REV	DATE	DESCRIPTION	CD
P1	31-01-13	Planning Submission	OR
P2	07-06-13	Planning Submission	OR
P3	16-12-14	Minor Material Amendments Application	NR
P4	04-02-15	Minor Material Amendments Application - REVISION WITHDRAWN	NR
P5	09-04-2017	Minor Material Amendments Application - REVISION WITHDRAWN	NR
P6	25-09-2017	Minor Material Amendments Application	AD
P7	25-10-2017	Minor Material Amendments Application	AD

KIDDERPORE AVENUE, LONDON
BLOCK L
BUILDING STUDIES
809_01_07_409
SCALE: 1:200 @A1 1:400 @A3

02 SE Elevation

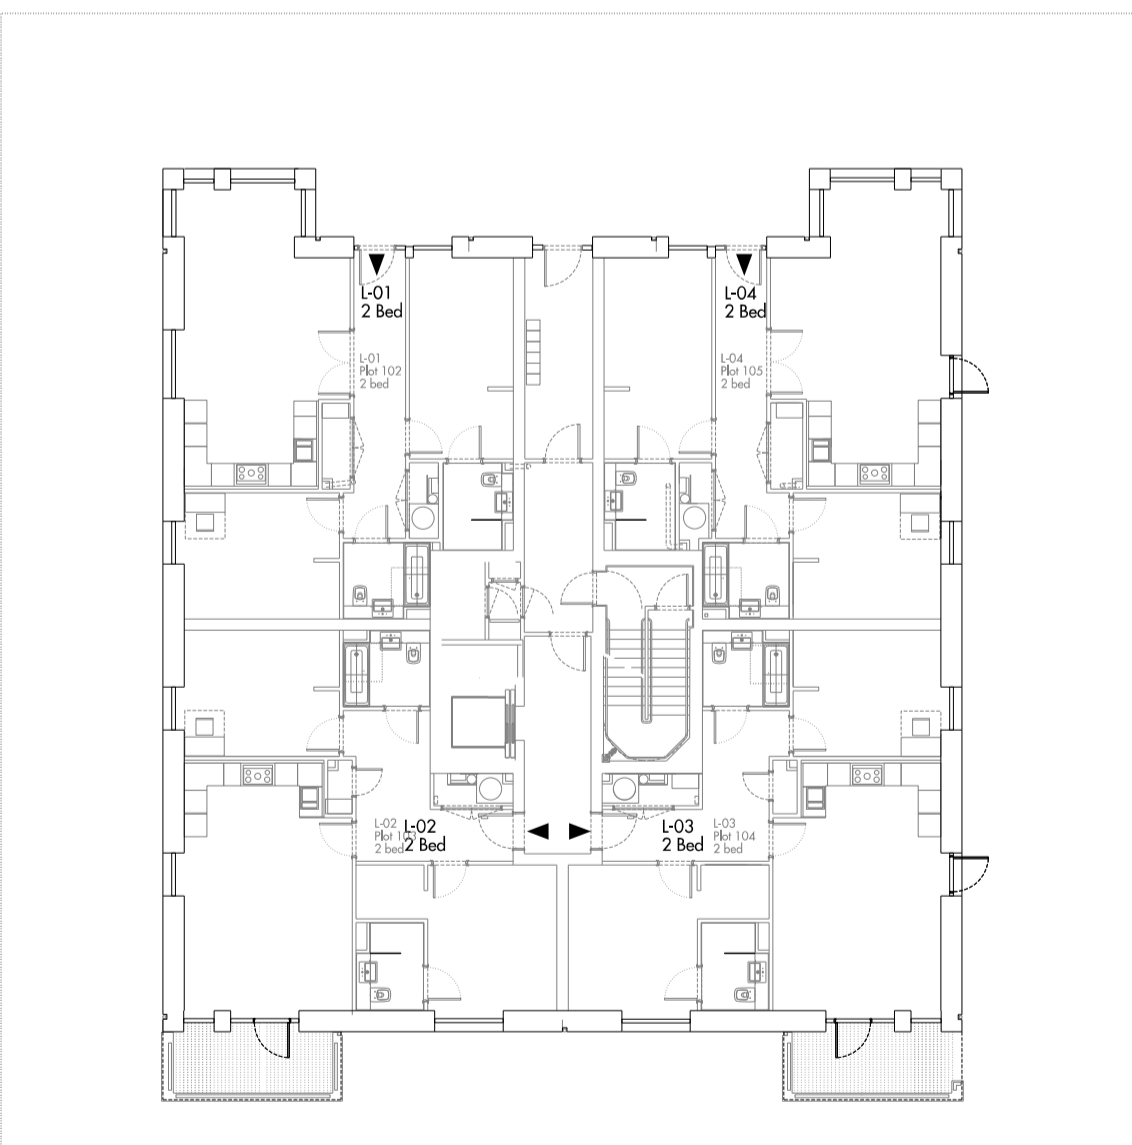
notes:
1. Obscure glass used in south east facade looking towards block M
2. Revised window location to prevent overlooking Block M
